**NEW YORK STATE THRUWAY AUTHORITY
DEPARTMENT OF ENGINEERING**

**ALBANY, NY
FEBRUARY 8, 2024**

**AMENDMENT NO. 1
TO**

**CONTRACT TANY 24-8
D214964
2" MILL AND INLAY, SAFETY
IMPROVEMENTS AND MISCELLANEOUS WORK
BETWEEN MILEPOST 47.6+/- AND MILEPOST 60.1+/-
IN THE NEW YORK DIVISION
OF THE NEW YORK STATE THRUWAY
IN ORANGE COUNTY**

TITLE OF PROJECT PAVEMENT RESURFACING AND SAFETY IMPROVEMENT	CONTRACT NUMBER: TANY 24-8
LOCATION OF PROJECT NY DIVISION MP 48.0 TO 60.1	DATE: 1/2024
TITLE OF DRAWING GENERAL PLAN	DRAWING NUMBER: GP-29

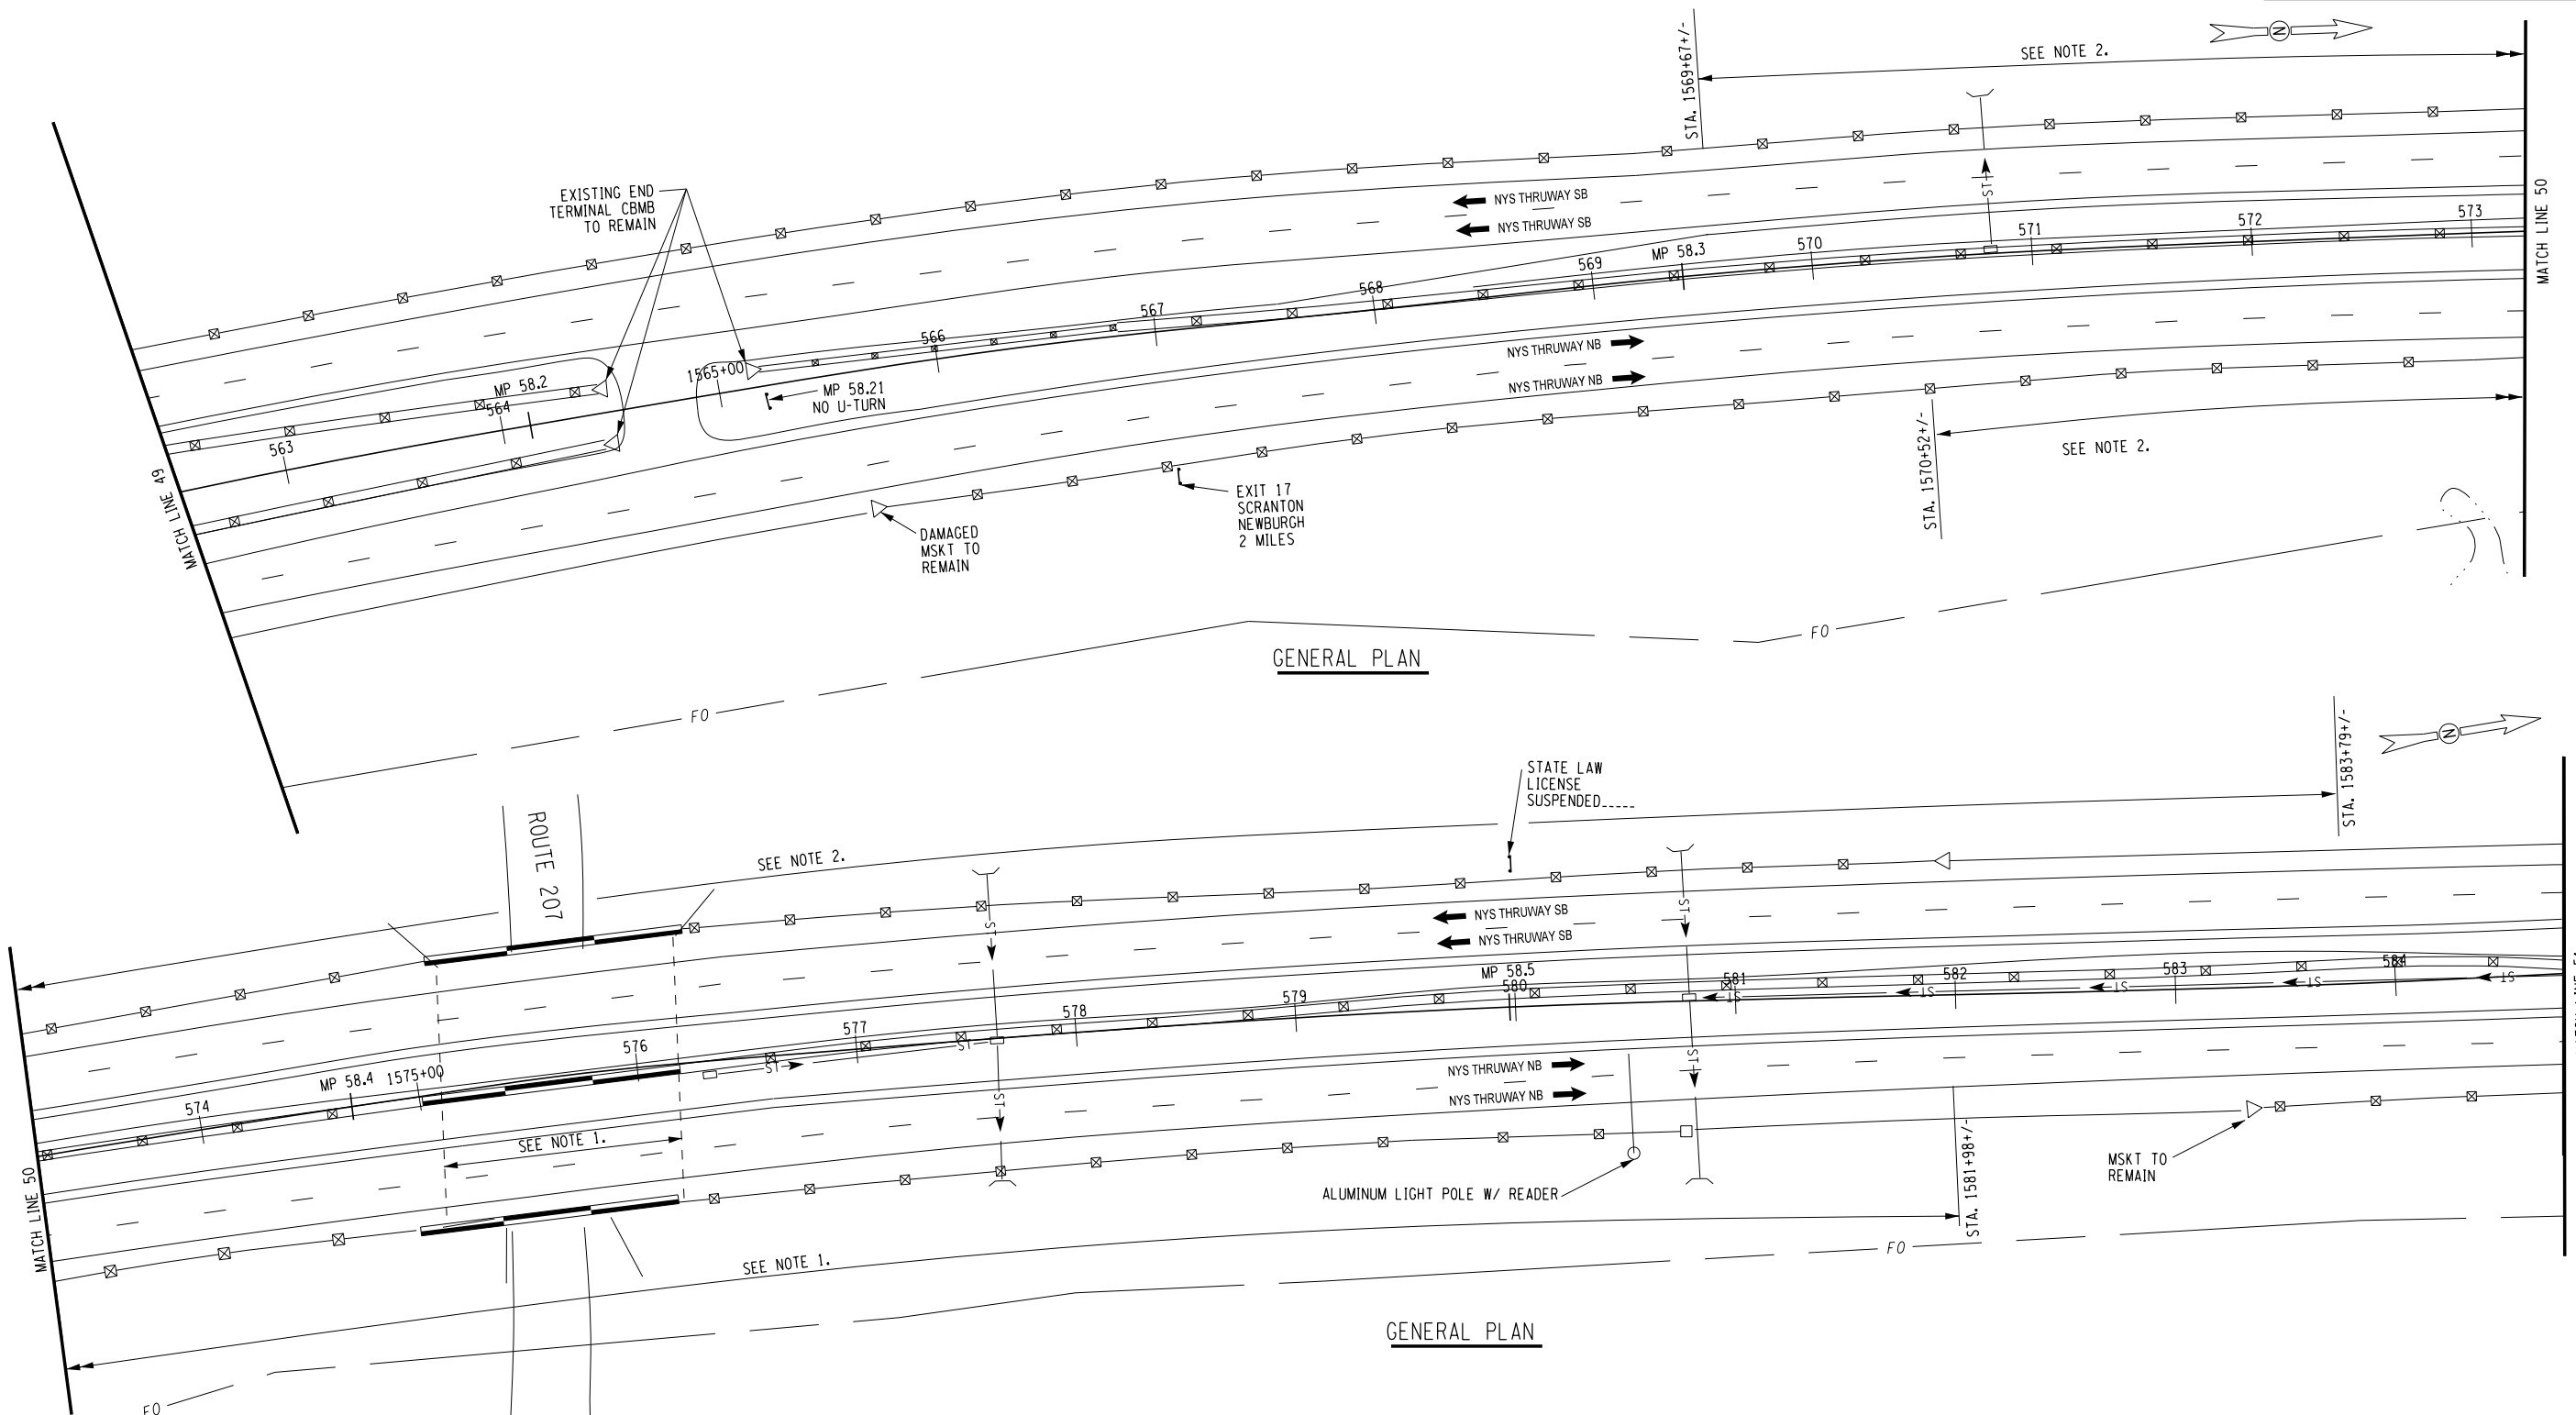
32. **DELETE** Drawing Number GP-29, Sheet 100 of 108, and **SUBSTITUTE** with the attached Drawing Number GP-29, Sheet 100-A1 of 108. Changed Note 1. last sentence to “...PAVED UNDER THIS PAVING PROJECT.”

- NOTES:
1. THIS BRIDGE WAS RECENTLY REPLACED UNDER TANY 19-29B. THE MAINLINE SHOULDERS BEFORE AND AFTER THIS BRIDGE WERE REPLACED AND DO NOT NEED TO BE PAVED UNDER THIS PAVING PROJECT.
 2. RIGHT SHOULDERS WITHIN THE LIMITS SHOWN ARE NOT TO BE PAVED. LEFT SHOULDERS ON THIS SHEET ARE NOT TO BE PAVED.

TITLE OF PROJECT PAVEMENT RESURFACING AND SAFETY IMPROVEMENT	CONTRACT NUMBER: TANY 24-8
LOCATION OF PROJECT NY DIVISION MP 48.0 TO 60.1	DATE: 1/2024
TITLE OF DRAWING GENERAL PLAN	DRAWING NUMBER: GP-32

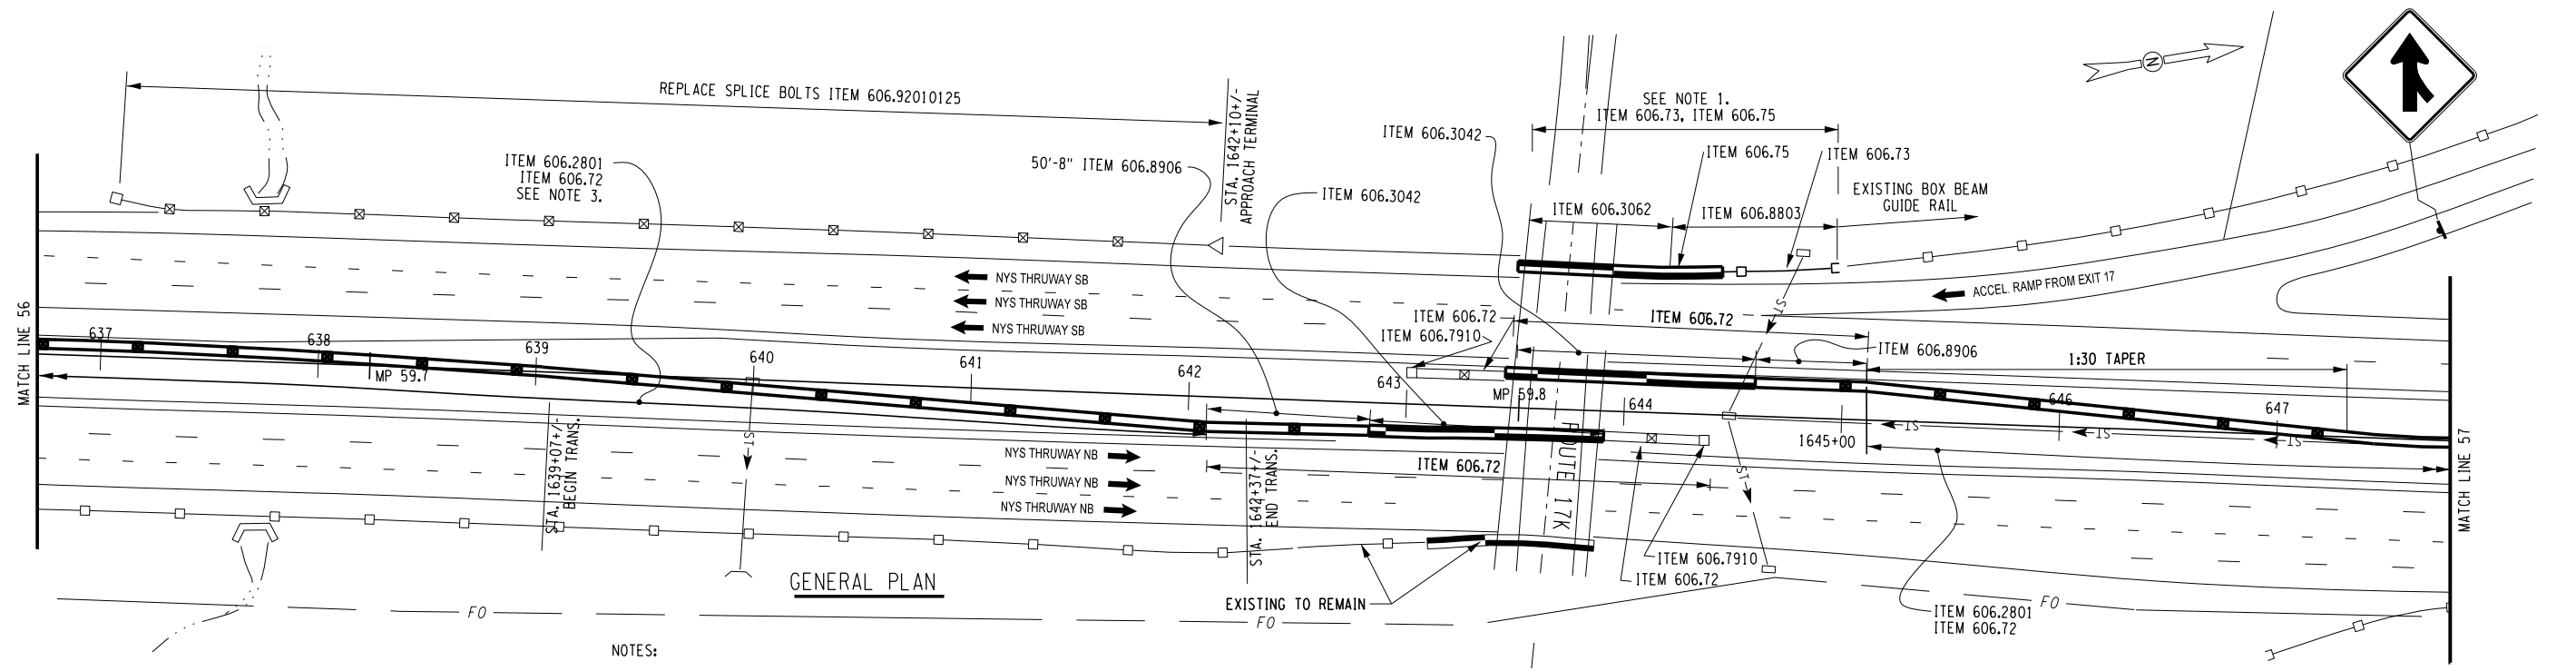
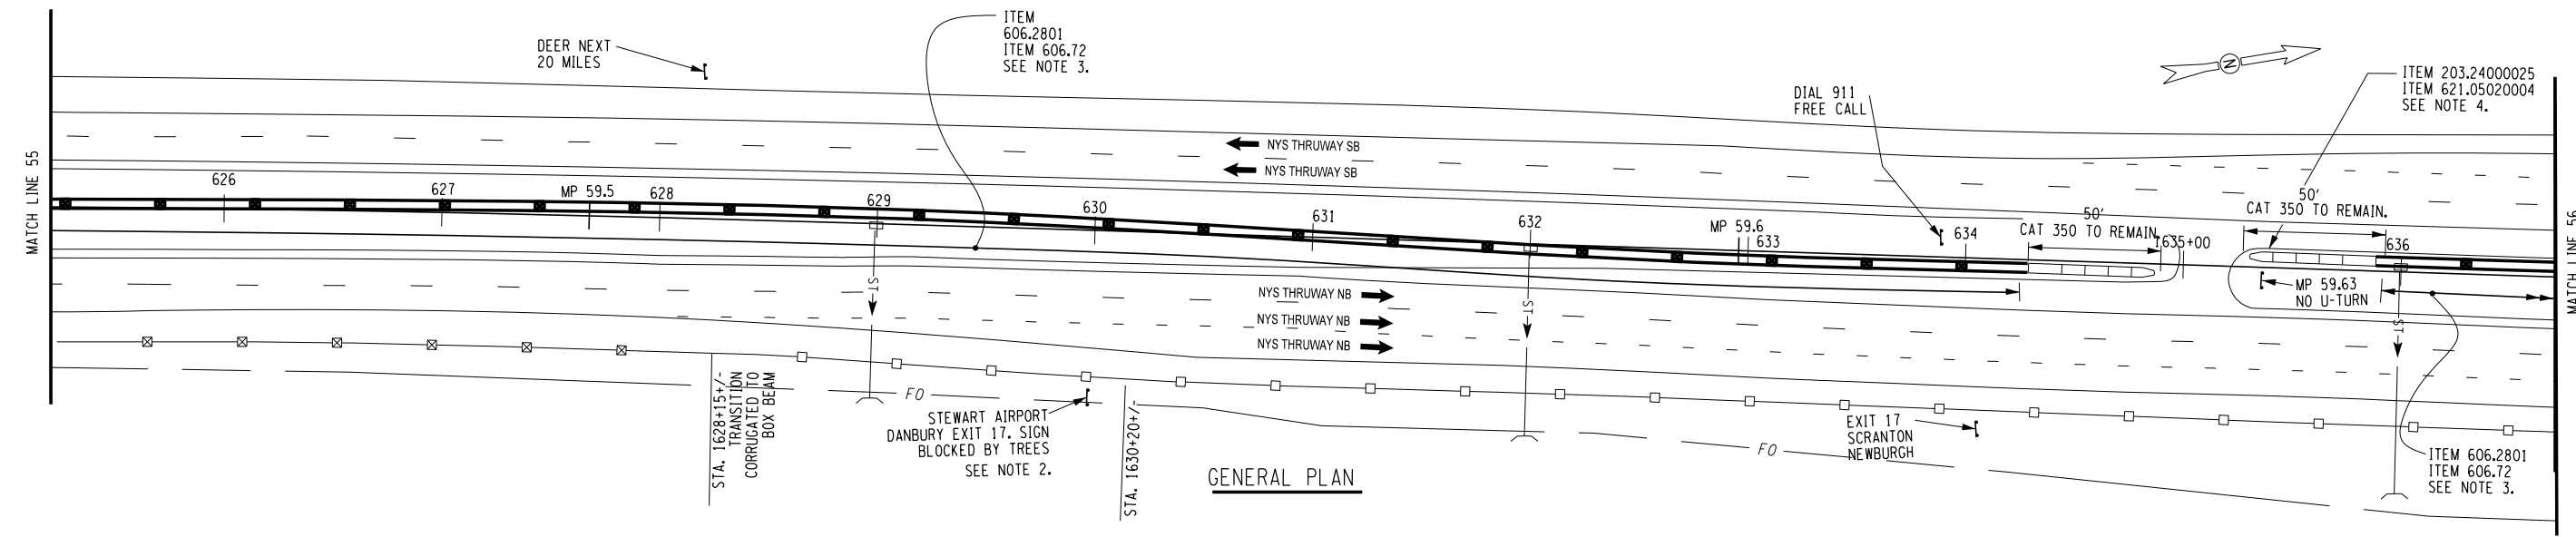
35. **DELETE** Drawing Number GP-32, Sheet 103 of 108, and **SUBSTITUTE** with the attached Drawing Number GP-32, Sheet 103-A1 of 108. Deleted the redundant barrier lengths previously shown for the Rte. 17K Bridge. Deleted Joint Detail A. Deleted reference to Note 6.

TITLE OF PROJECT: PAVEMENT RESURFACING AND SAFETY IMPROVEMENT
 LOCATION OF PROJECT: NY DIVISION MP 48.0 TO 60.1
 TITLE OF DRAWING: GENERAL PLAN

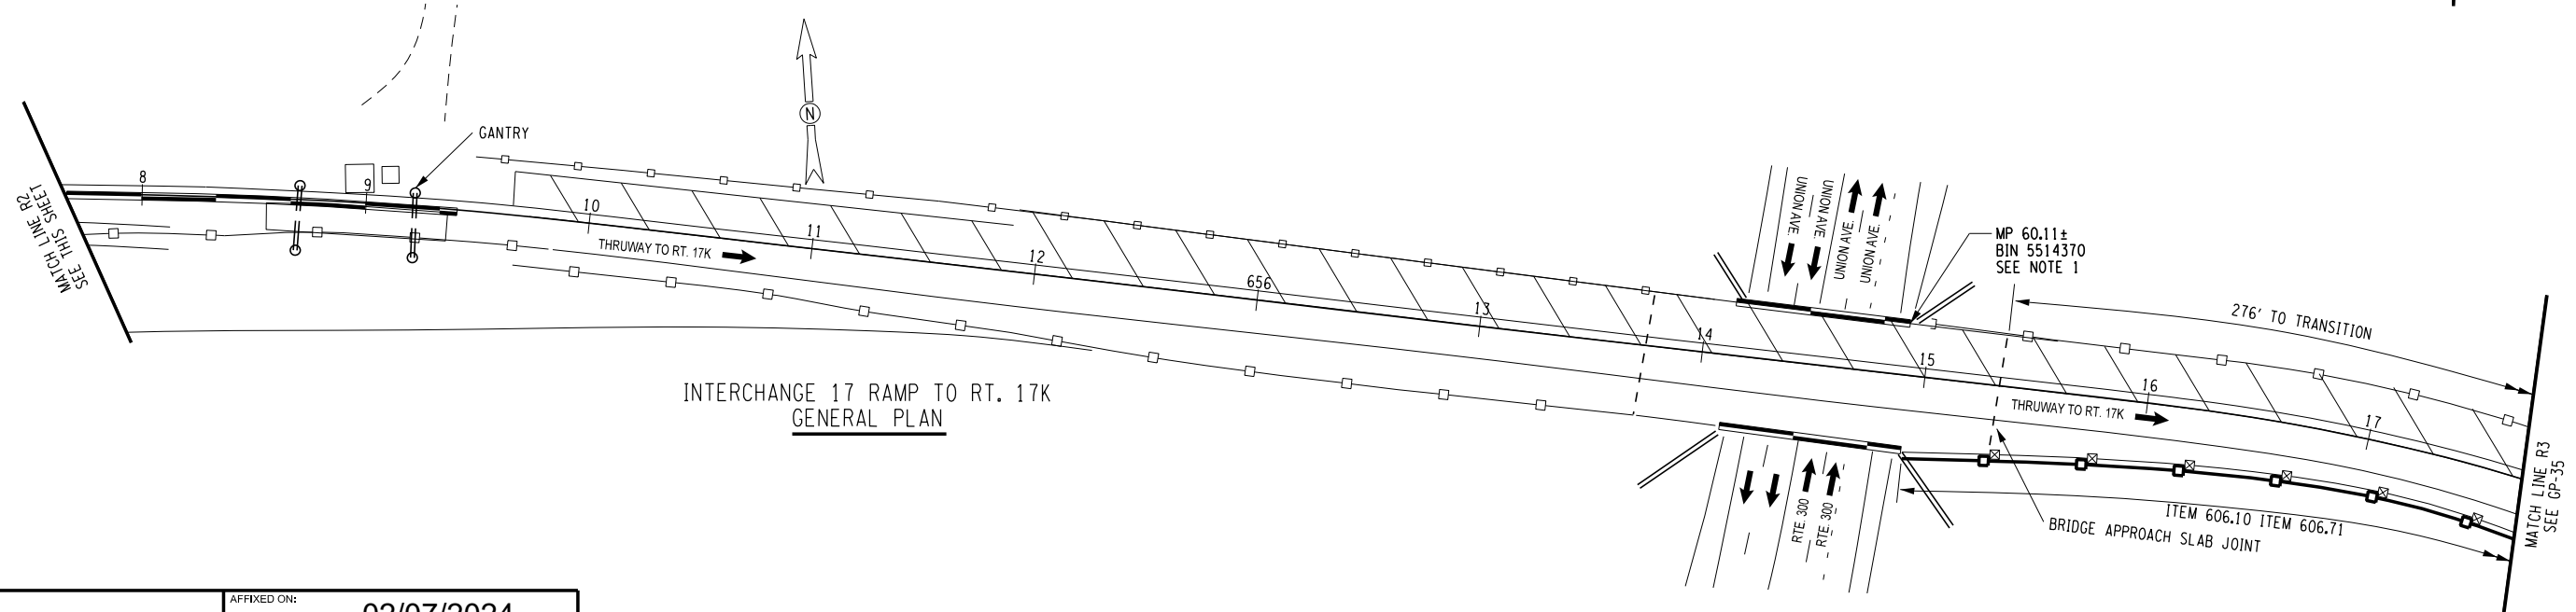
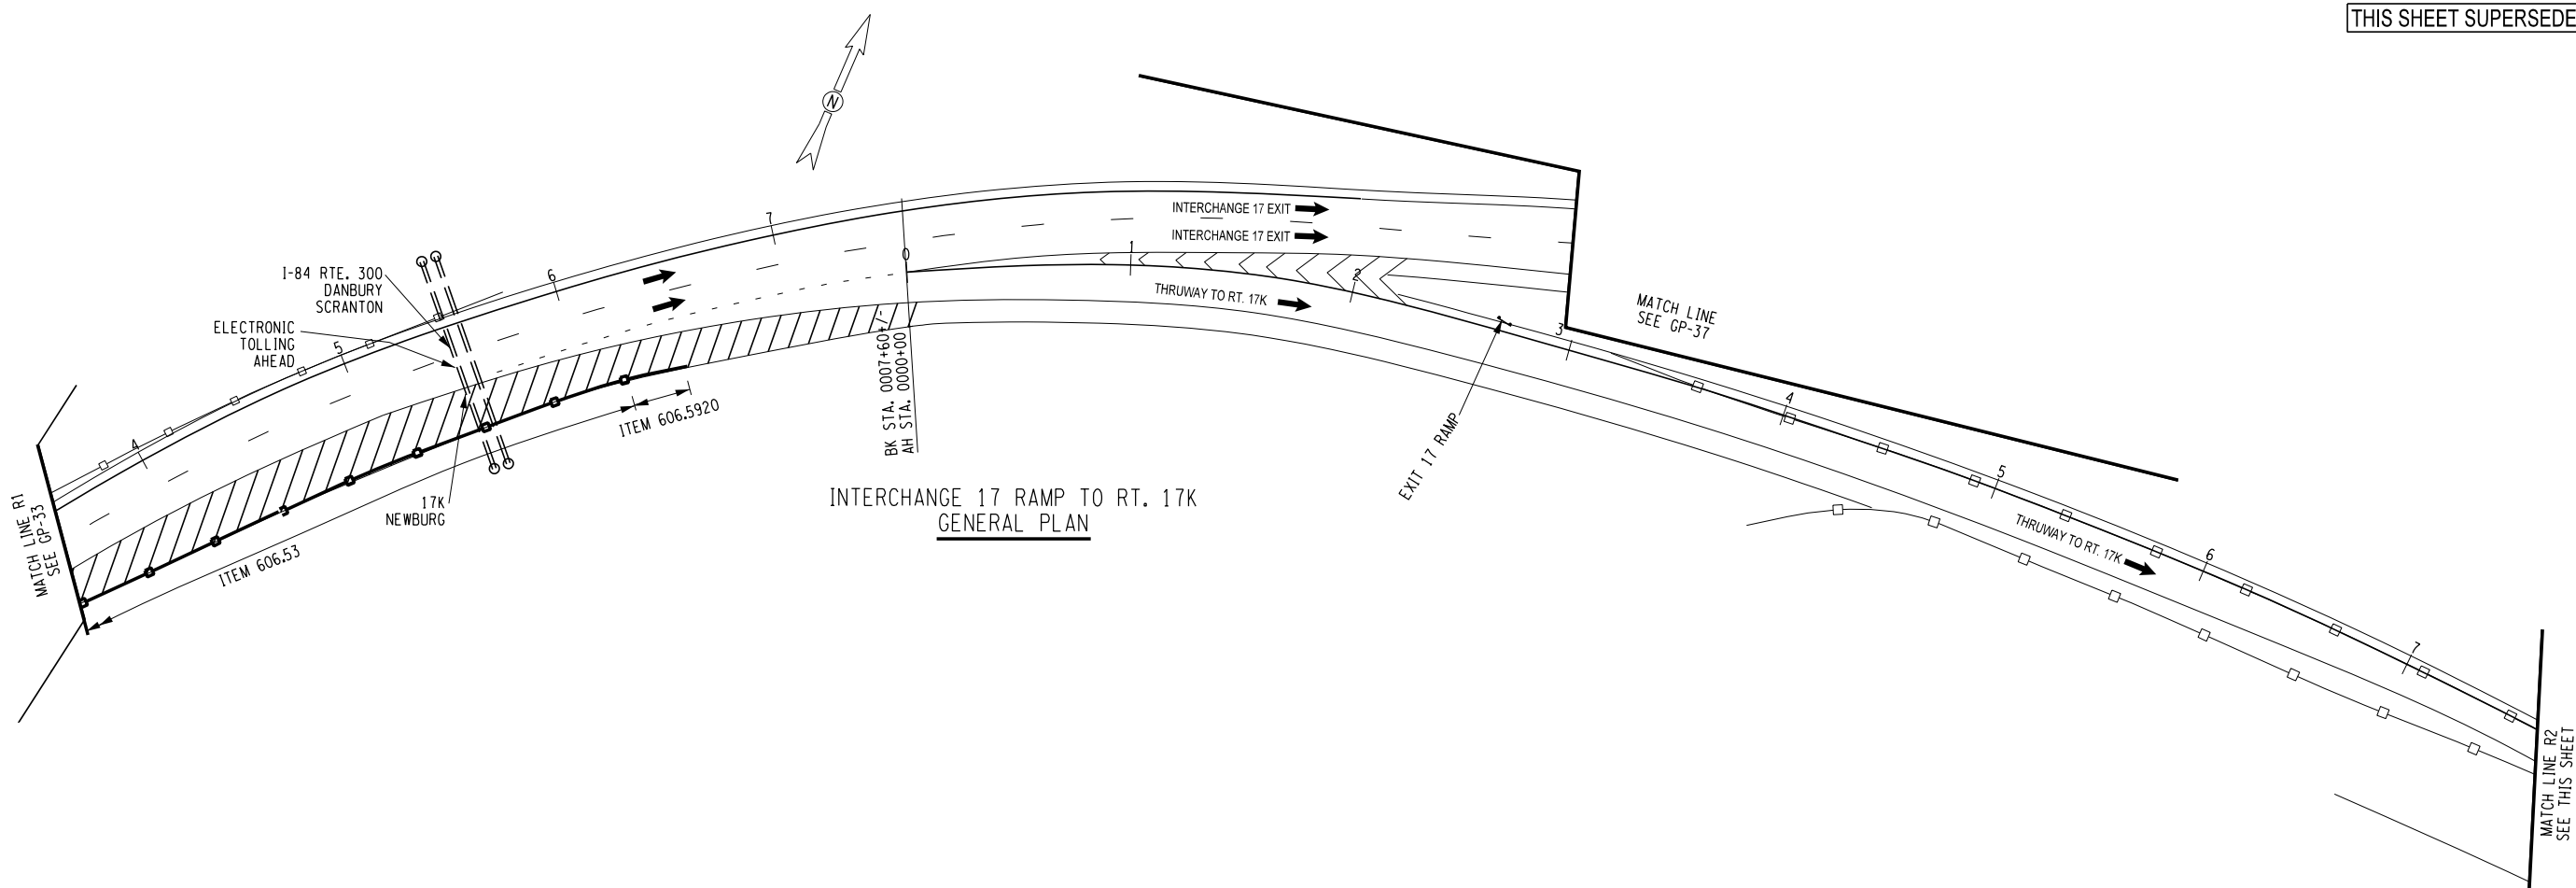
36. **DELETE** Drawing Number GP-33, Sheet 104 of 108, and **SUBSTITUTE** with the attached Drawing Number GP-33, Sheet 104-A1 of 108. Changed the Northbound Exit 17 D-Ramp right side rail to be reset from existing to proposed.
